A D D E N D U M

TO: All prospective bidders on Project No. IR-094-4(47)132, Job No. 3, to be let on November 9, 1984

REPAIR & OVERLAY PORTLAND CEMENT CONCRETE BRIDGE DECKS IN MORTON COUNTY FEDERAL AID PROJECT NO. IR-094-4(47)132

CONSTRUCTION SIGN AND BARRICADE LOCATION DETAILS

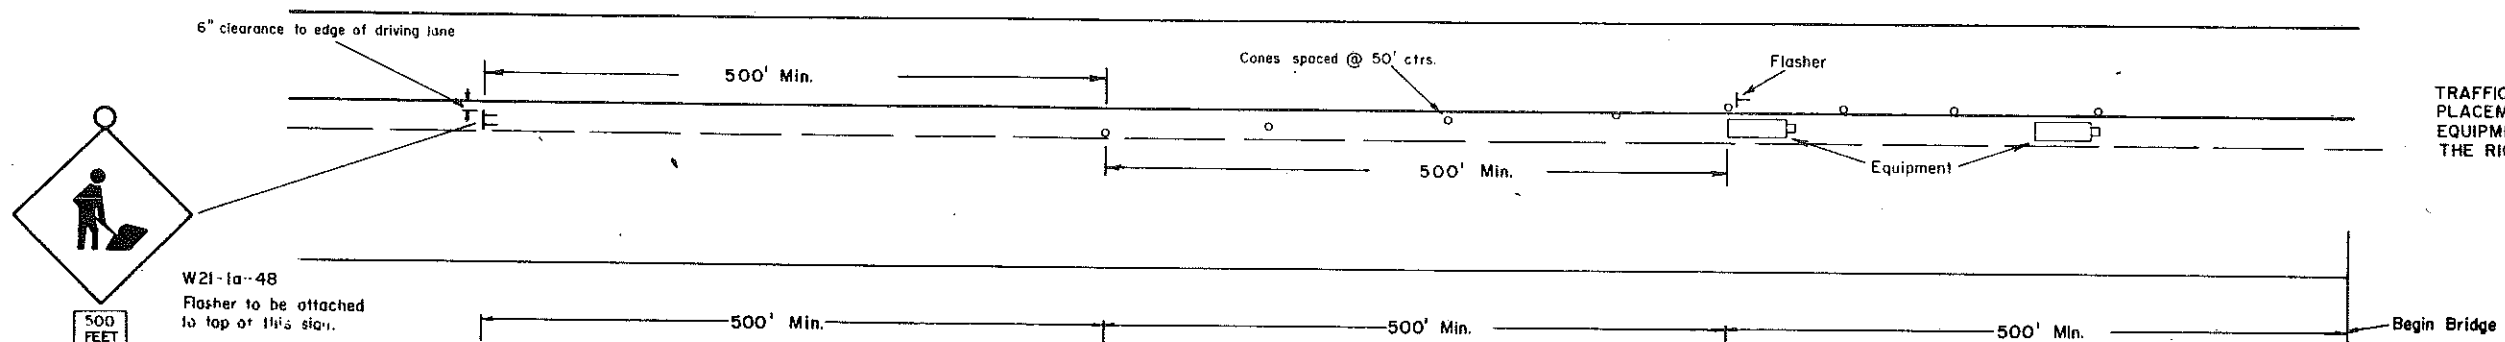
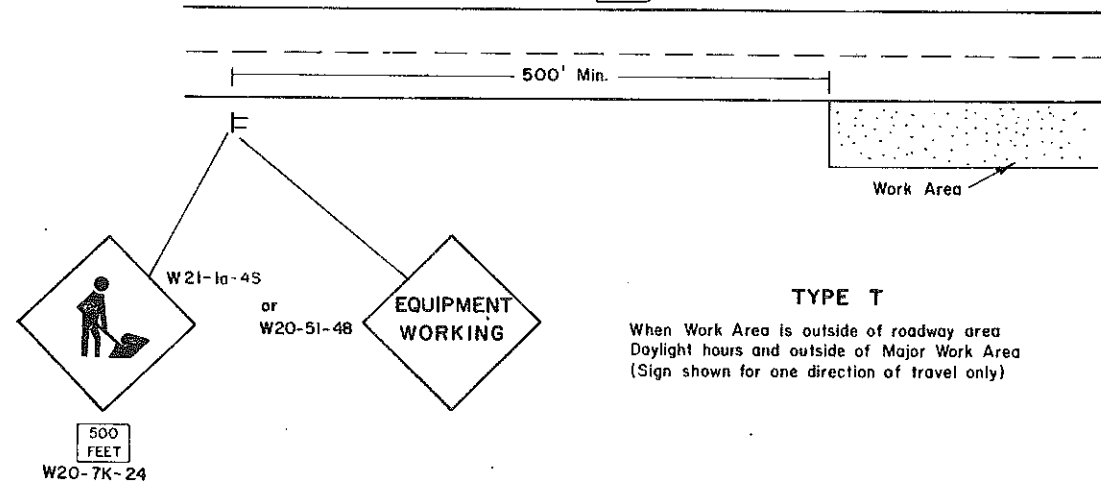
Sheet 48 - Sheet has been added to provide bridge painting construction signing details.
